APPENDIX A. RUNNING DESIGN CHANGES/FIELD SERVICE BULLETINS

The factory provided these ten Field Service Bulletins to 8X32 dealers and customers. Each Bulletin describes a remedial procedure for a specific problem, or a hardware change necessary to implement an improvement in the machine's design.

URSA MAJOR, Inc.

Fig.1 Location of 3 PROM's

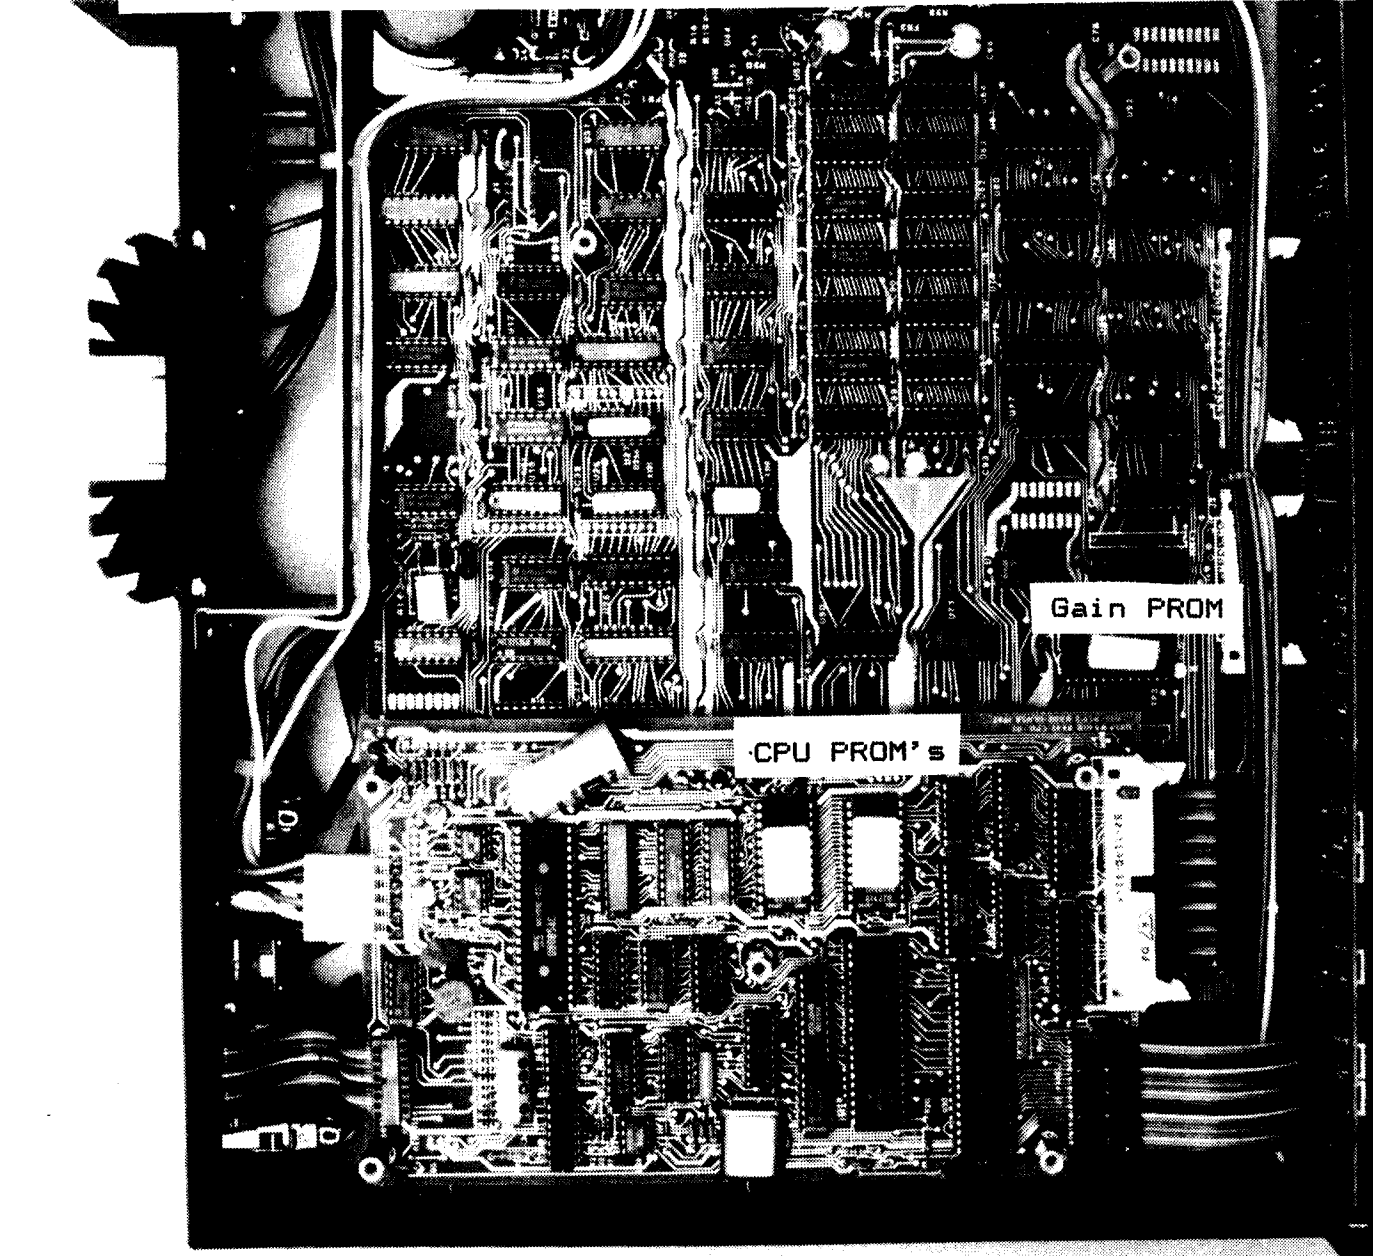
Use Fig.1 to locate the 3 PROM's to be changed. Note the pin 1 end of U7: the replacement IC must go in exactly this way. Using the IC extractor, or a small screwdriver, gently remove the IC and set it aside on the foam pad. Next, lift the PROM 0633-5 (or 0742-5) provided with this kit from the foam pad and check it to be sure that the pins are parallel and straight in both axes. Carefully position the IC with the pin 1 end toward the left, the same end where the pin 1 of the original IC was placed. Refer to Fig.2 to clarify which end of the IC is pin 1 if you are in doubt. On some IC's, there may be no notch at the pin 1 end, but a small dot, circle, diamond or other symbol. If you put the IC in backwards it will be destroyed! Carefully mesh the pins of the IC in the 24 holes of the socket, jiggling, squirming, looking very carefully to be sure that they are lined up and then press down, gently at first, a little bit more firmly if necessary, to seat the IC all the way in the socket. Inspect carefully (if possible with a small mirror) to see if any of the pins have been bent under the body or out to one side.

Finally, locate the Gain PROM (see Fig.1) on the motherboard right near the right edge of the CPU board, and replace it with the new PROM, part number 0527-7.

Fig.3 ANA Board: locations of changed R's and C's

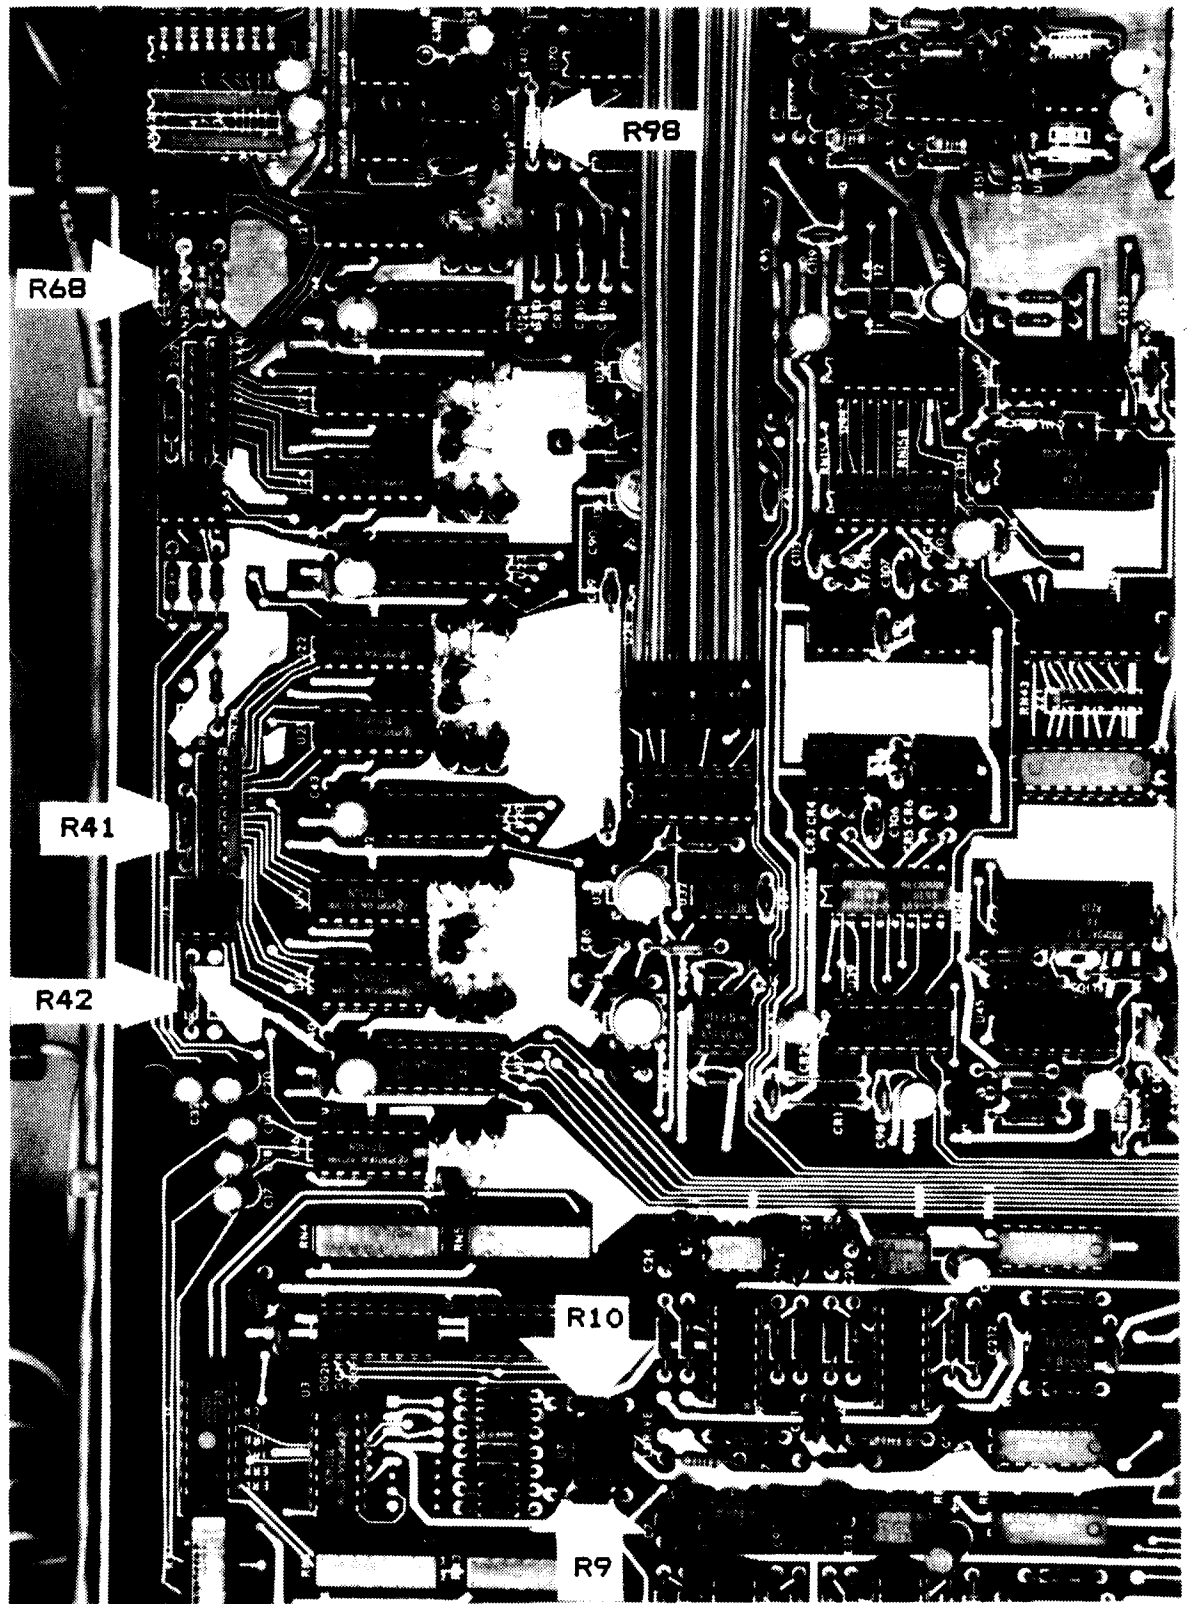
5. Following the procedure of (4) above, change the following resistors:

Component #	Old Value	New Value
i)	R68	2K, 5% (red,black,red, gold)	3.09K, 1% (orange,blk,white,brown)
ii)	R98	jumper (white)	4.99K, 1% (yel,white, white,brown)
iii)	R9,R10	5.1K,5% (green,brown,red, gold)	10.0K, 1% (brown,blk,blk,red)

- i) C300 .018uF, 5%: tack solder across R98 (just installed).
- ii) C301 .0039uF,5%: tack solder across R41
- C302 .0039uF,5%: tack solder across R42
(R41 and R42 are 12K,5%: brown,red,orange, gold)

Fig.5 Resistor Tack-Soldered in place at R68 position.

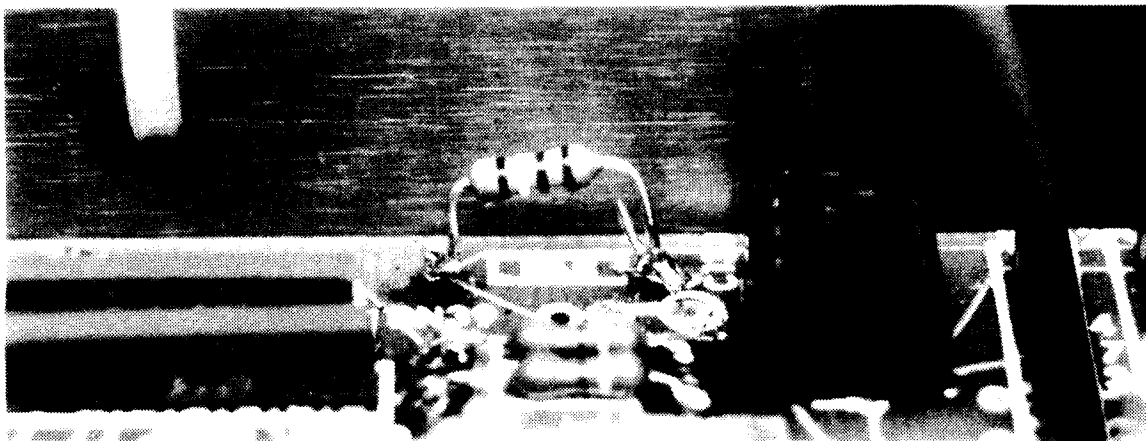
Now tack solder the new resistor across the old, soldering at the points where the old resistor leads enter the PC board. Refer to Fig.5.
